## COMMITTEE OF THE WHOLE MEETING

October 20, 2020

- B. Consider an Amendment to Chapter 23, Building Codes and Appendix B, Penalty, Salary, Bonds, and Fees
  - C. Consider the Riverview Townhomes Proposal

## **Overall Site Comments:**

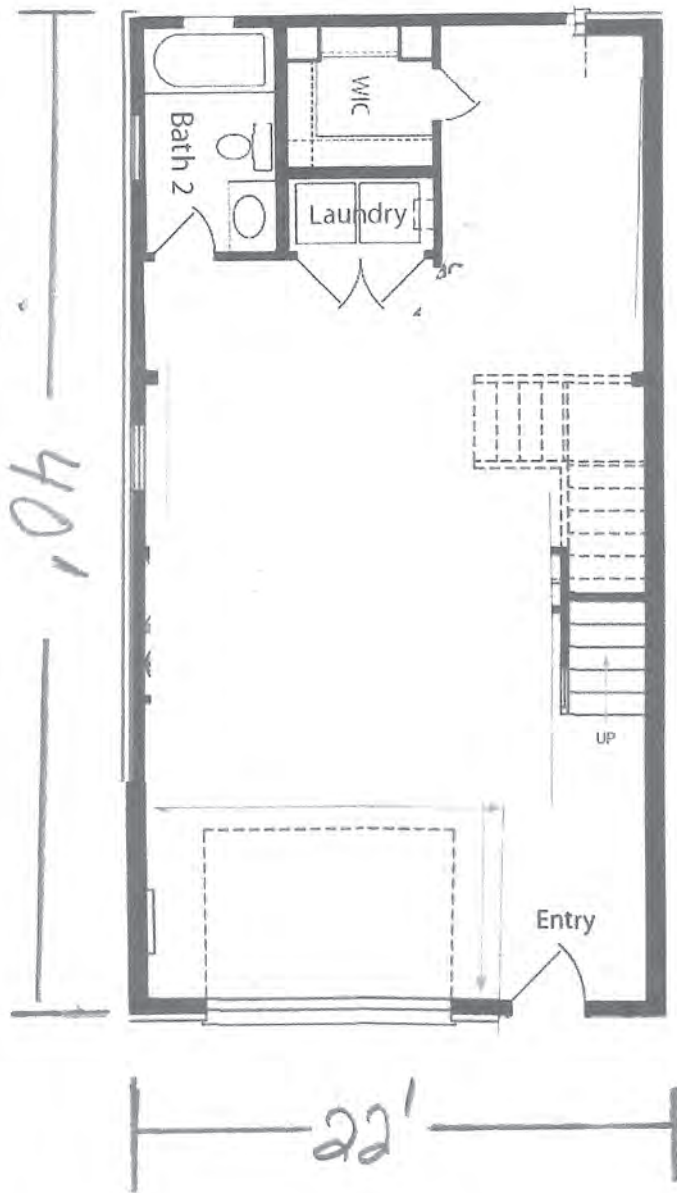
- Provide an emergency vehicle access plan using the turning radius schematic provided for the Algonquin Lake in the Hills Fire Protection District Tower Ladder Truck. This access plan should include all driveways / roadways of the property. **IFC 503.2.4 Turning Radius**
- All fire department access roads shall be a minimum of 20 feet of unobstructed width and 13'6" of unobstructed height. **IFC 503.2.1 Dimensions**
- Mark the west curb line and entrance to the complex as "No Parking Fire Lane" with either fire lane signage or curb paint. **IFC 503.3 Marking**
